07/4107/DD01

ST MARY'S UNIVERSITY COLLEGE	
SECTION C'C Road & Hedge	
Tender	
SCALE 1:50 @ A3	DRAWING NO. 1155.103 A
DATE 06.07.2009	
DRAWN JN

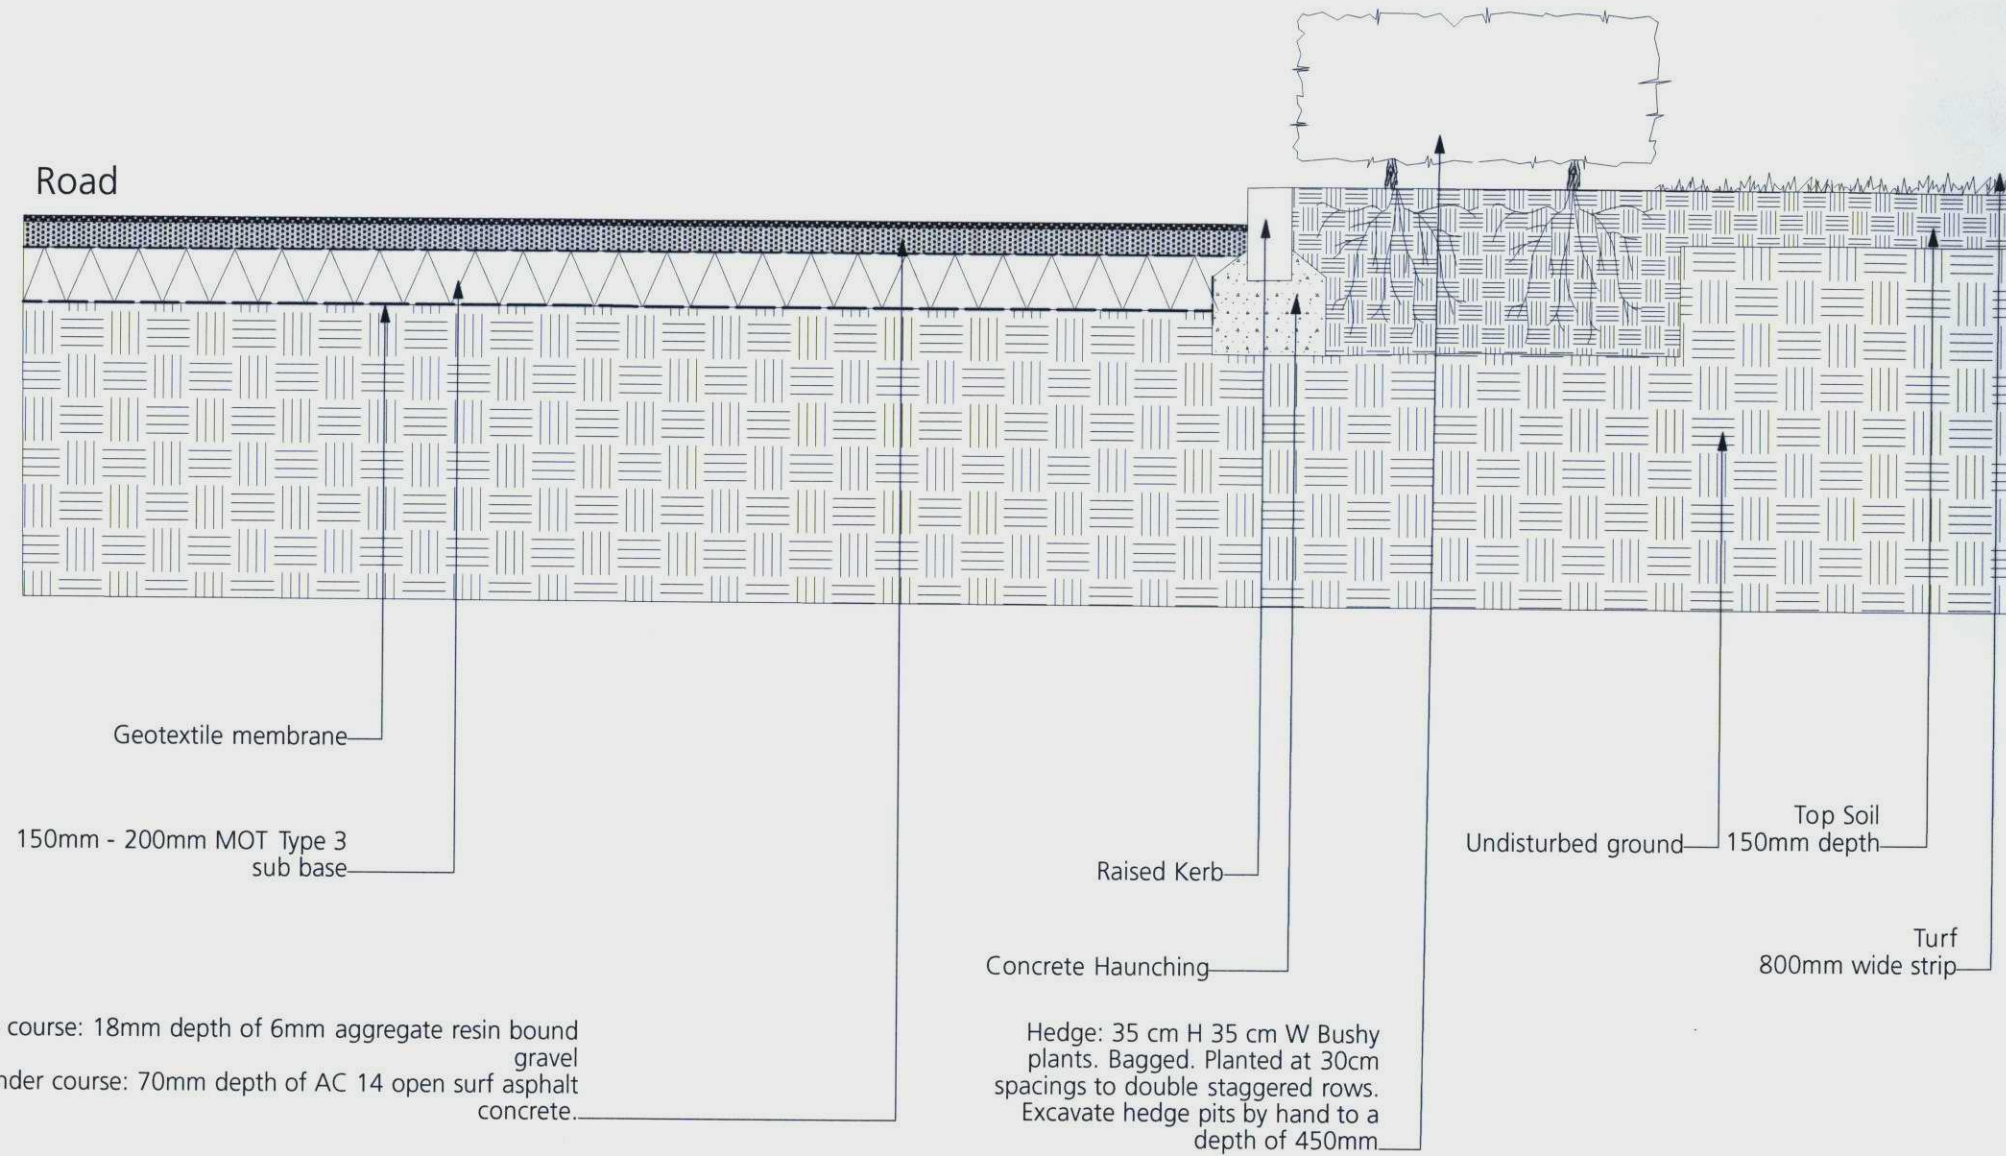
ISSUED FOR PLANNING APPROVAL	15.12.09	JN
ISSUING MATERIAL REVISED: CELLULOSE SYSTEM NOT REQUIRED BELOW PATH AS LOCALISED GROUND DISTURBANCE REQUIRED TO CONSTRUCT BUILDING FOUNDATIONS.		JN
TENDER ISSUE		JN
